VALUE ENGINEERING STUDY

**PI No. 621340-
SR 5 from SR 2 to Proposed McCaysville Bypass**

**PI No. 620490-
McCaysville Bypass from SR 5 to Tennessee State Line
Fannin County, Georgia**

Sept. 1, 2016

PROPOSAL NUMBER: B-1.0 PAGE NUMBER: 3 of 5

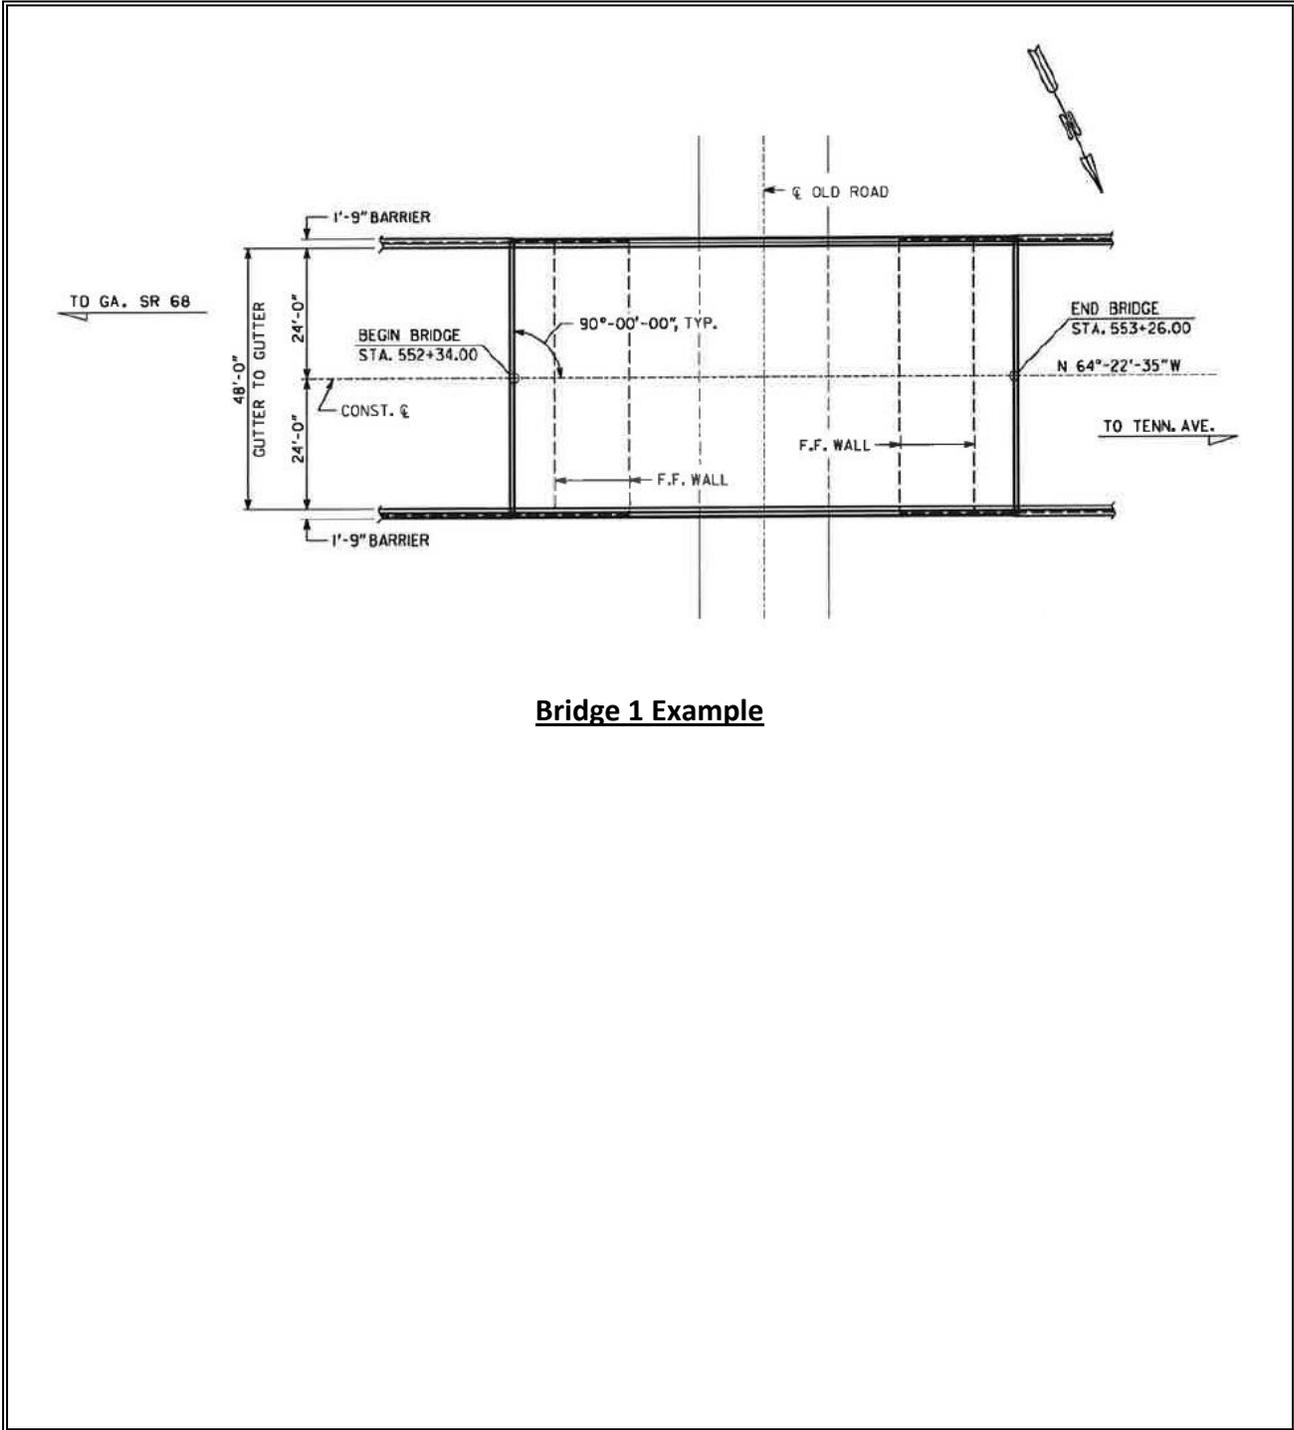
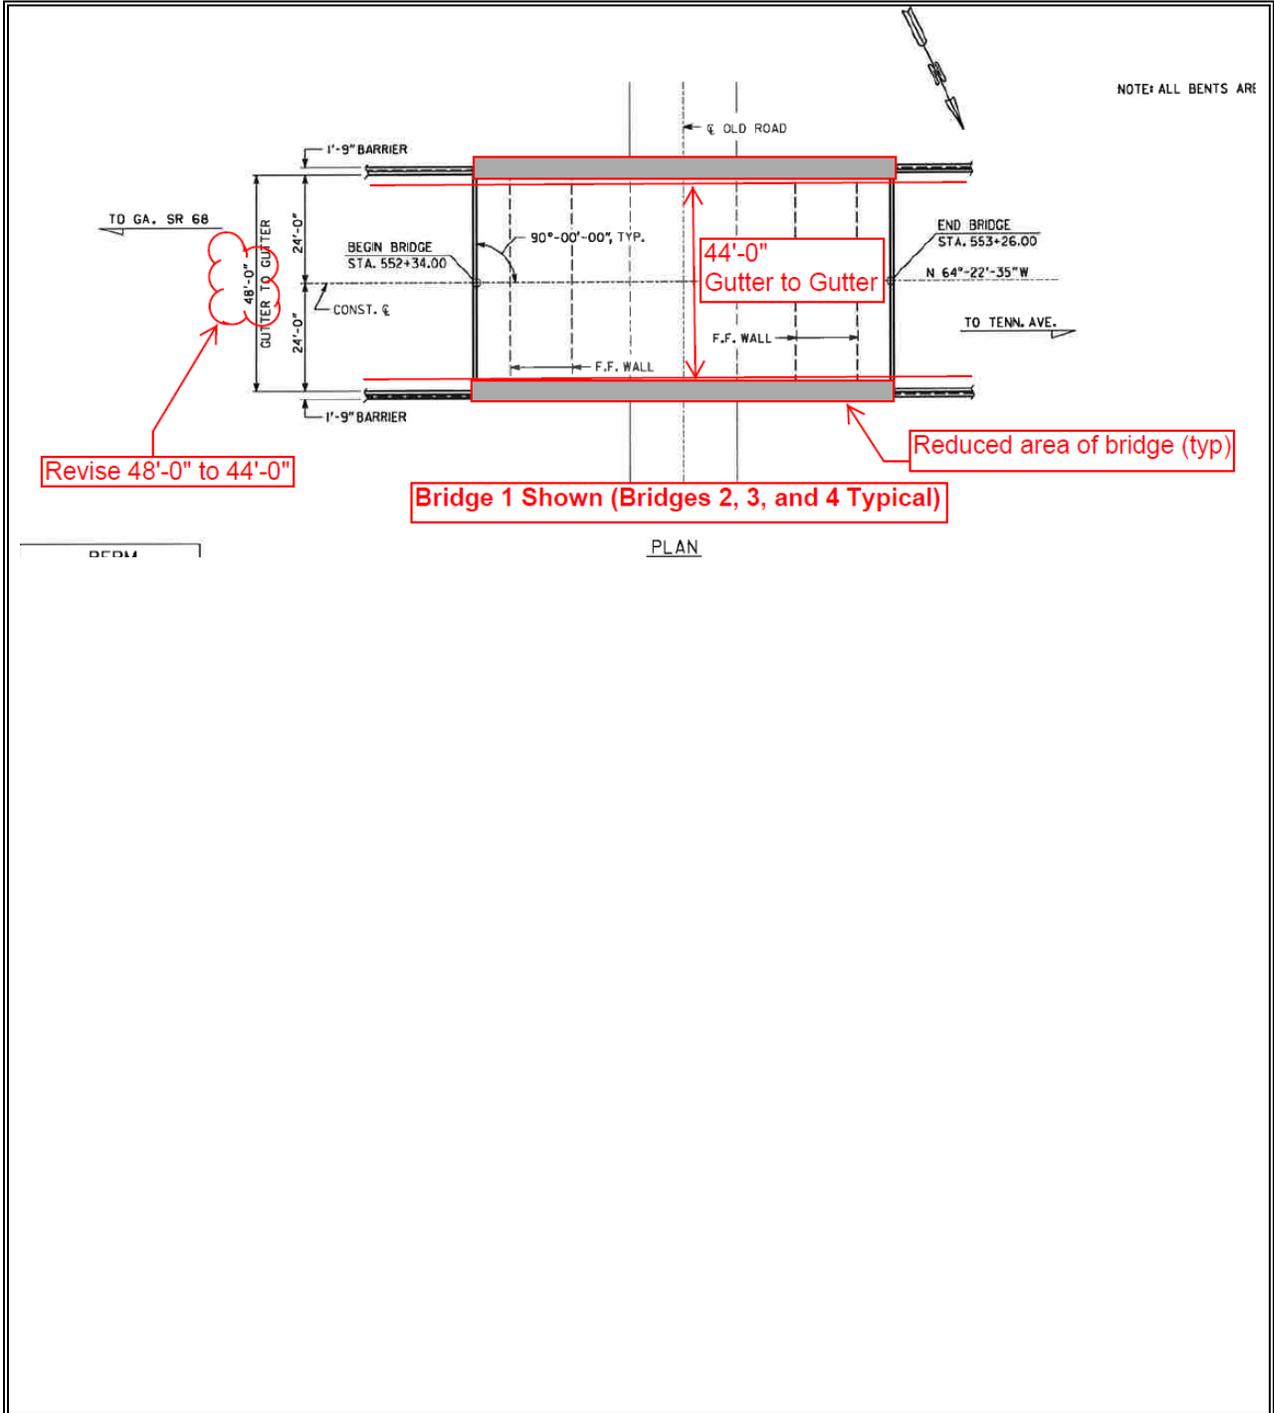
ORIGINAL DESIGN:	The current design proposes 48'-0" clear bridge width between barriers for Bridges 1 thru 4.
PROPOSED CHANGE:	It is proposed to reduce the clear bridge width between barriers to 44'-0" for Bridges 1 thru 4. This width is based on two 12-foot travel lanes, a 4-foot flush median and 8-foot shoulders on each side.
JUSTIFICATION:	The proposal meets GDOT Bridge Policy 2.9.2.1 for total bridge width on rural state routes for ADT > 2,000 (Travel Way + 16'). Bridges 1 thru 4 are located on the new location truck bypass segment; thus, there are no traffic maintenance or staging considerations to warrant the additional bridge width.
ADVANTAGES:	DISADVANTAGES:
<ul style="list-style-type: none"> • Reduces costs • Reduces schedule 	<ul style="list-style-type: none"> • Reduces available paved shoulder

PROPOSAL NUMBER: B-2.0

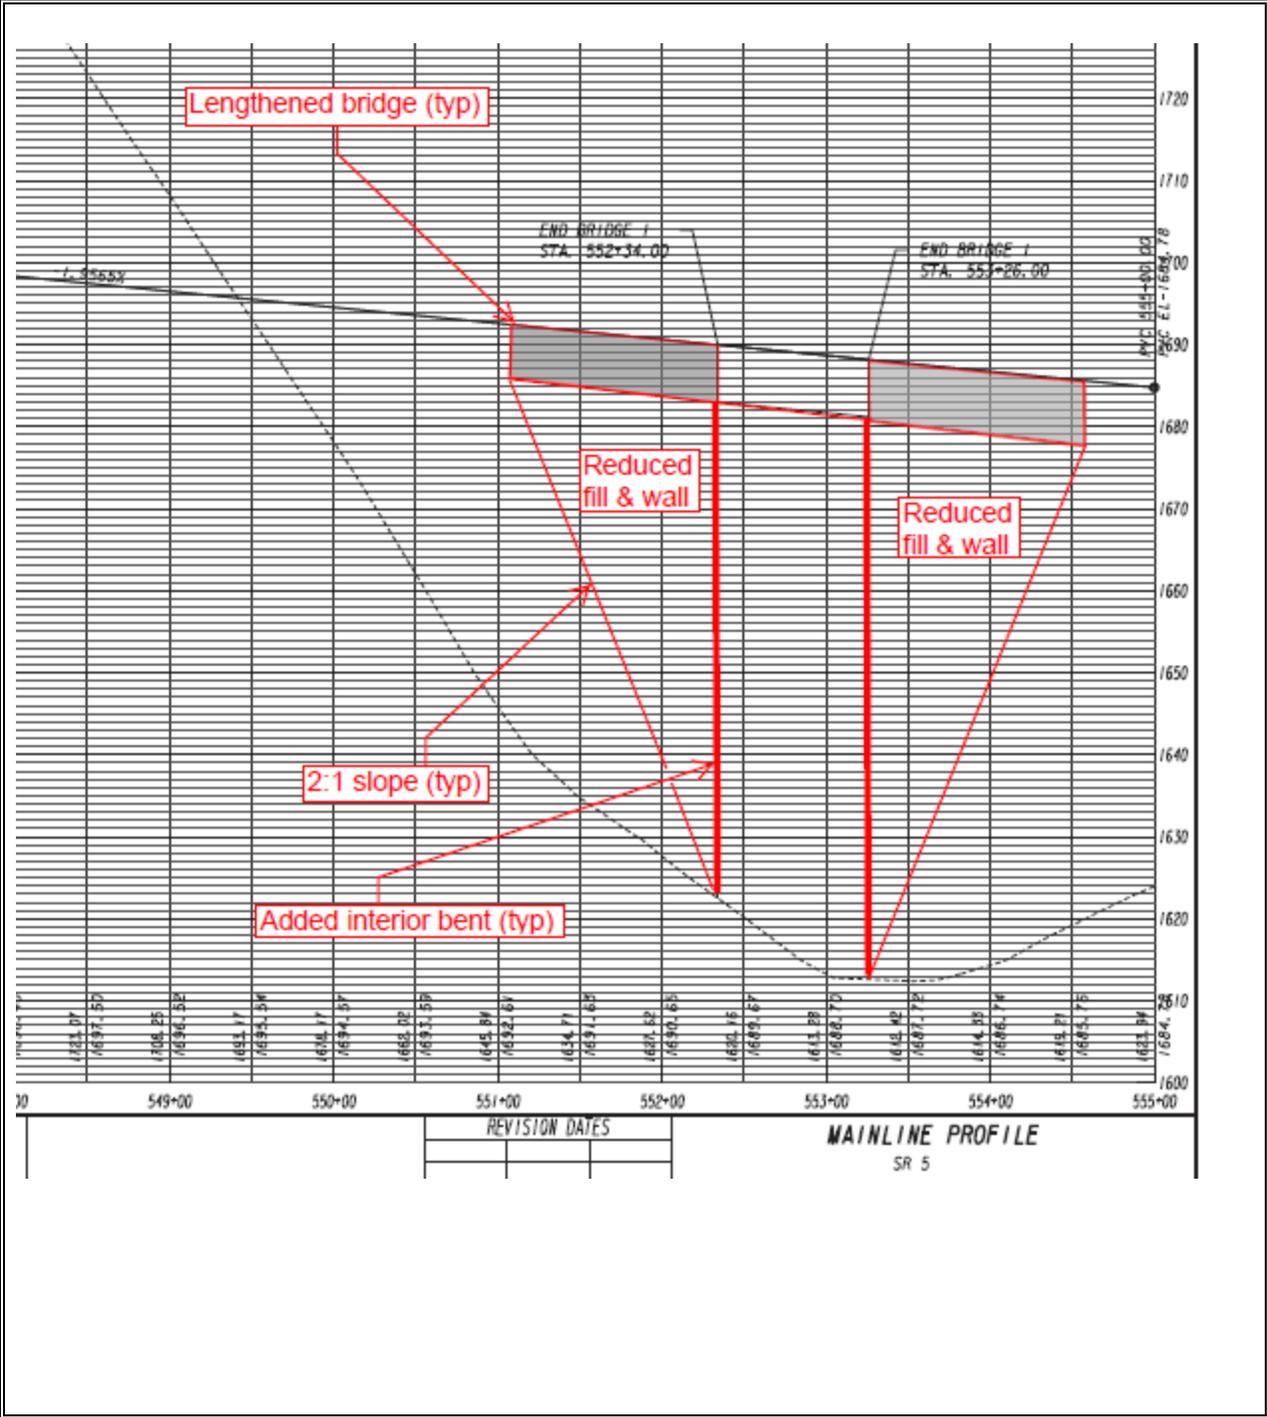
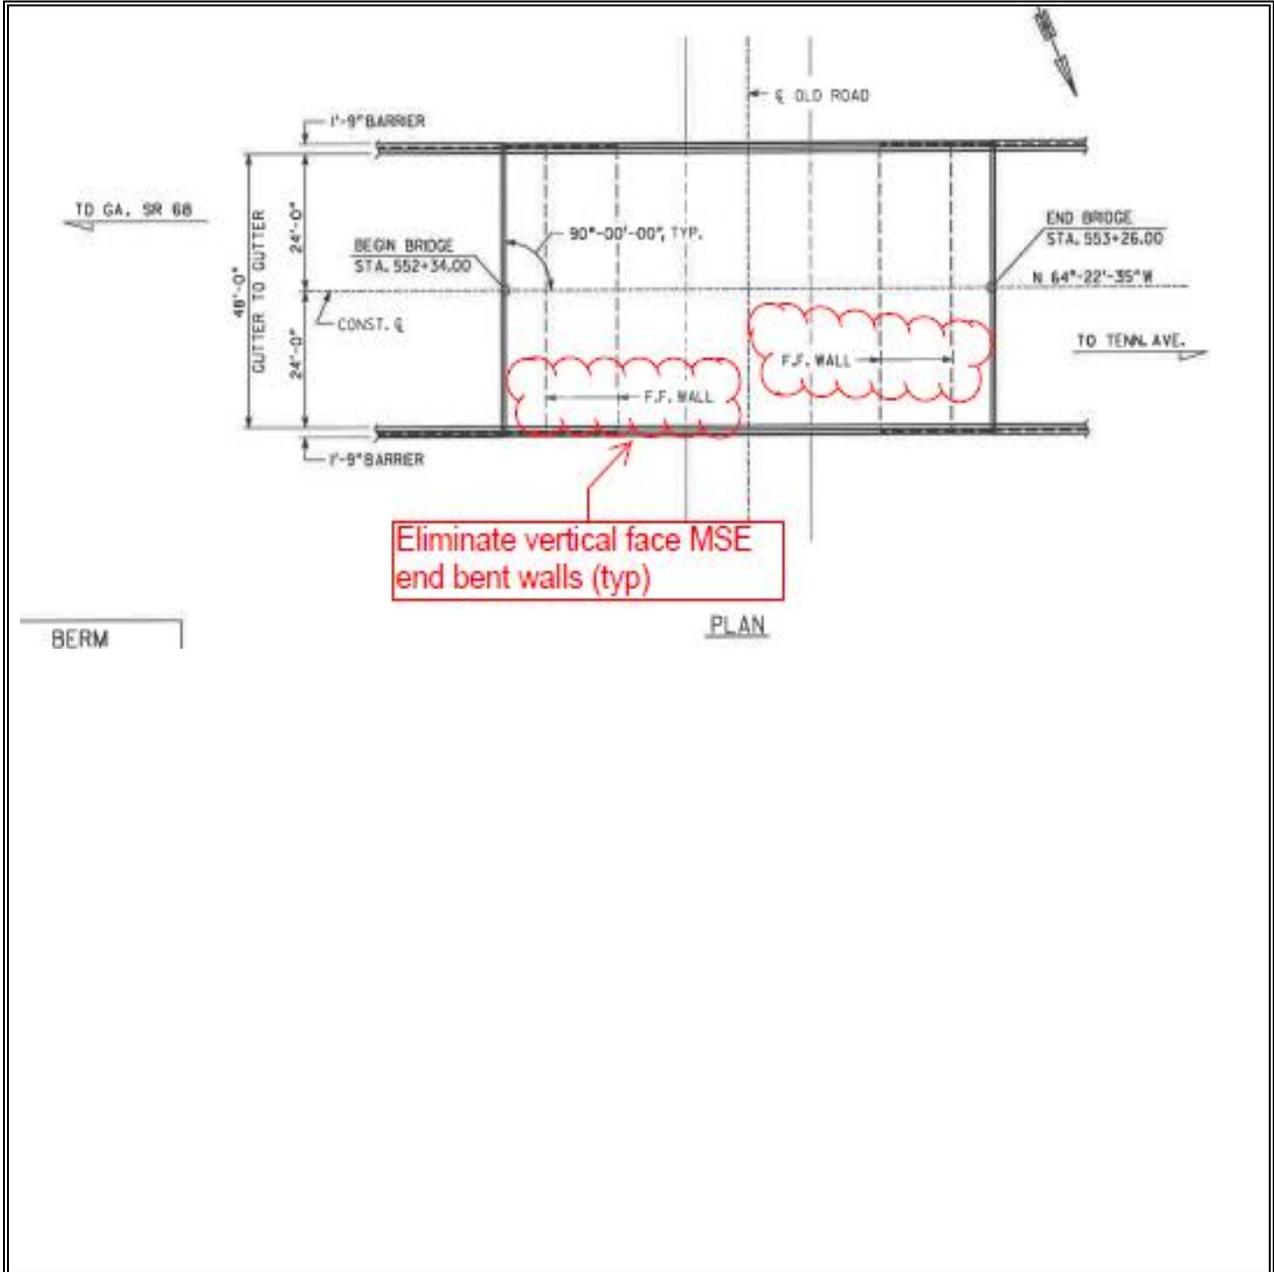
PROPOSED CHANGE: It is proposed to revise Bridge 1 to a 3-span, 346-foot long bridge with 2:1 end slopes and pile supported end bents. The 3-span arrangement with end slopes eliminates the vertical face MSE walls and allows the side MSE walls to follow the 2:1 slope.

JUSTIFICATION: The proposed change reduces the complexity and quantity of retaining wall construction at fill heights exceeding 60 feet by substituting it with a conventional PSC beam span. This proposal assumes the use of conventional pile-supported end bents and the extension of spans within current, typical PSC beam span ranges. The proposal continues to use MSE retaining walls along the sides of the roadway to maintain R/W impacts the same as the current design.
